UNITED STATES PATENT AND TRADEMARK OFFICE

Office Action Summary	Application No. 10/552,427	Applicant(s) BLASE ET AL.	
	Examiner DAVID M. SINCLAIR	Art Unit 4125

DETAILED ACTION

Fig 1: Altered version of Holshausen '957 – Fig. 18

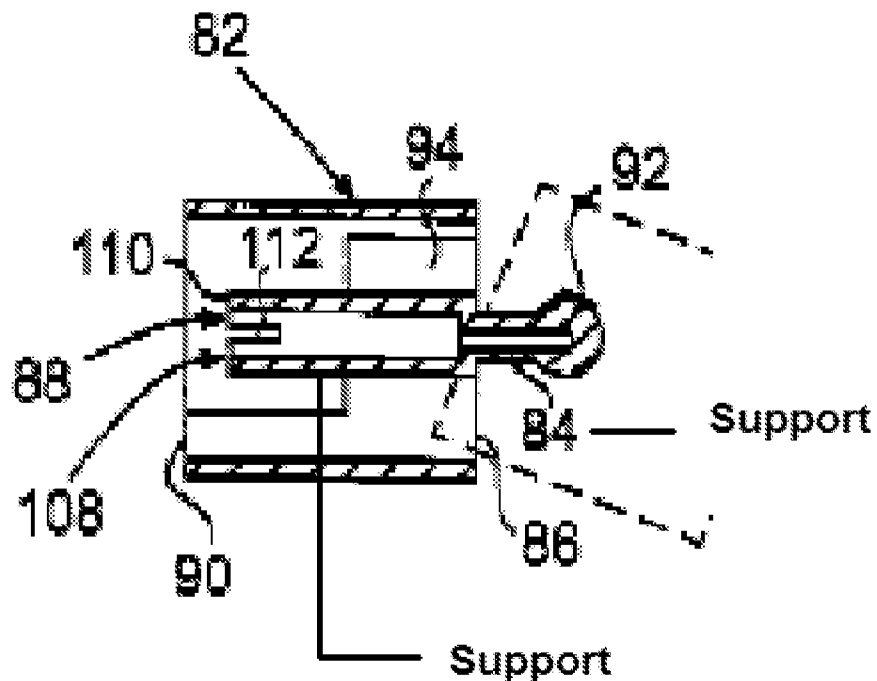
Cable-routing device according to Claim 1, characterized in that the joint elements are each supported by a support and the supports of the two joint elements of a link are offset relative to each other in a direction perpendicular to the longitudinal axis of the cable-routing device (seen in below figure).

Fig 2: Altered version of Holshausen '957 – Fig. 18

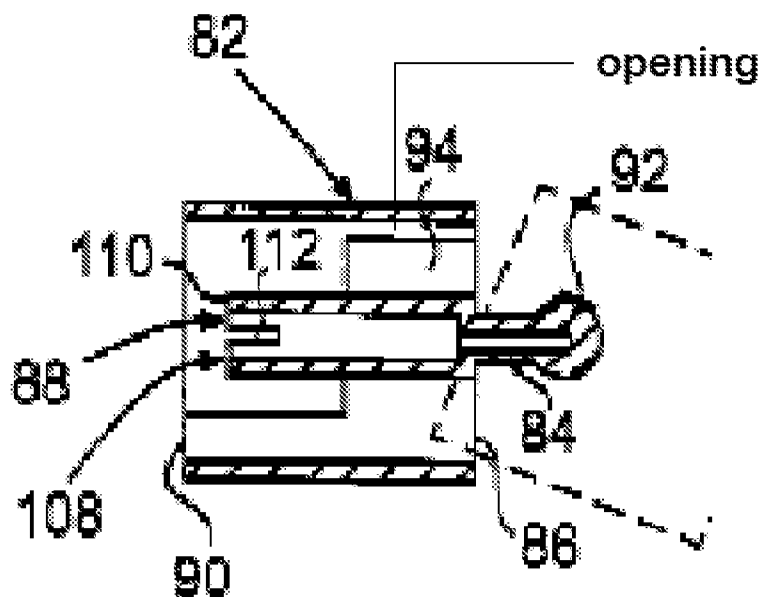
Cable-routing device according to Claim 1, characterized in that links are provided that are provided with at least one brace (94), extending transverse to the longitudinal direction of the cable-routing device and possibly bearing a guide element, and in that the brace displays at least one opening (seen in below figure) extending in the longitudinal direction of the cable-routing device, which can optionally serve to accommodate a line or other device within the cable-routing device.

Fig 3: Altered version of Holshausen '957 – Fig. 16

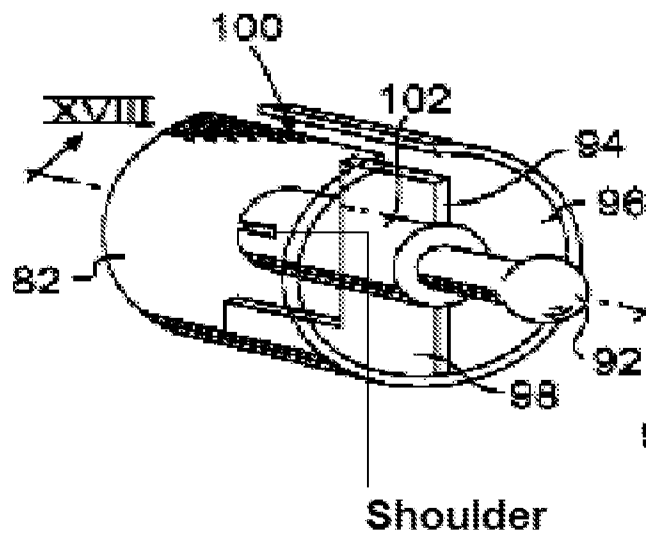
Cable-routing device according to Claim 11, characterized in that the opening displays a shoulder (seen in below figure), a distance away from the inside of the joint body receptacle, against which a tool can be positioned in the manner of a lever.
